Access Compliance Report

Public Rights-of-Way

Intersection ID: 10031809	Main Street: MILLENNIUM_AV	Cross Street: AUDUBON_PARK_DR	Location: S
ADA ID: E5BFA2B9032D	Ramp Type: Perp	Initial Pass/Fail: Pass	Overall Compliance: No
Severity Score: 15			
Codes/Mitigation Info/Possible Solution		Field Measurements/Component Compliance

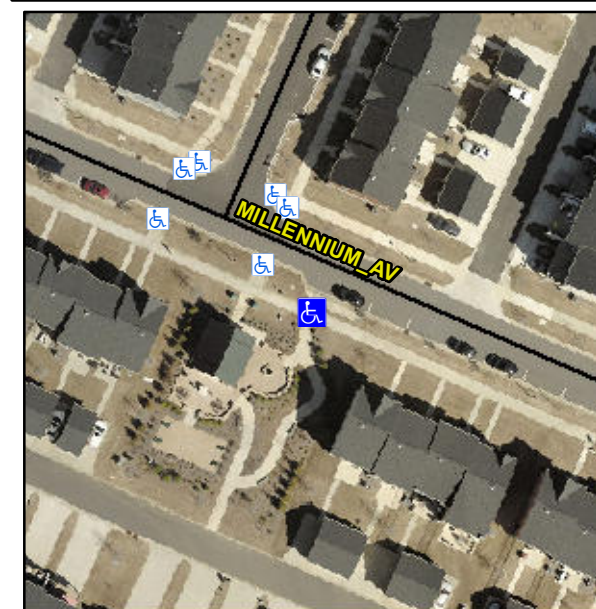
Not Found, R305, R302.7, R304.5.4

Compliance	Description	Data	Compliance	Description	Data
N/A	Ramp Length (in)	33.0	Yes	Ramp Slope (%)	6.3
Yes	Ramp Width (in)	60.0	Yes	Ramp XSlope (%)	1.3
N/A	Flare Type LT	None	N/A	Flare Type RT	N/A
N/A	Flare Slope LT (%)	N/A	N/A	Flare Slope RT (%)	N/A
N/A	Flare Traversable LT?	N/A	N/A	Flare Traversable RT?	N/A
Yes	Landing Length (in)	72.0	No	DWS Provided?	No
Yes	Landing Width (in)	60.0	N/A	DWS Contrast?	No
Yes	Landing Slope (%)	1.2	N/A	DWS Length (in)	N/A
Yes	Landing X Slope (%)	2.1	N/A	DWS Full Width?	No
N/A	Landing Curb? (Y/N)	No	N/A	DWS Offset (in)	N/A
N/A	Shared Landing?	No			
No	Gutter Ponding?	Yes	No	Gutter Slope (%)	5.9
Yes	Gutter Lip Ht (in)	0.0	Yes	Gutter X Slope (%)	1.0
N/A	Painted X Walk1?	No	N/A	Painted X Walk2?	N/A
	X Walk 1 Direction	To N		X Walk 2 Direction	N/A
N/A	X Walk 1 Width (in)	N/A	N/A	X Walk 2 Width (in)	N/A
	X Walk 1 Slope (%)	1.2		X Walk 2 Slope (%)	N/A
	X Walk 1 X Slope (%)	2.2		X Walk 2 X Slope (%)	N/A

**Remove & Replace Entire Ramp.
Remove & Replace Gutter.**
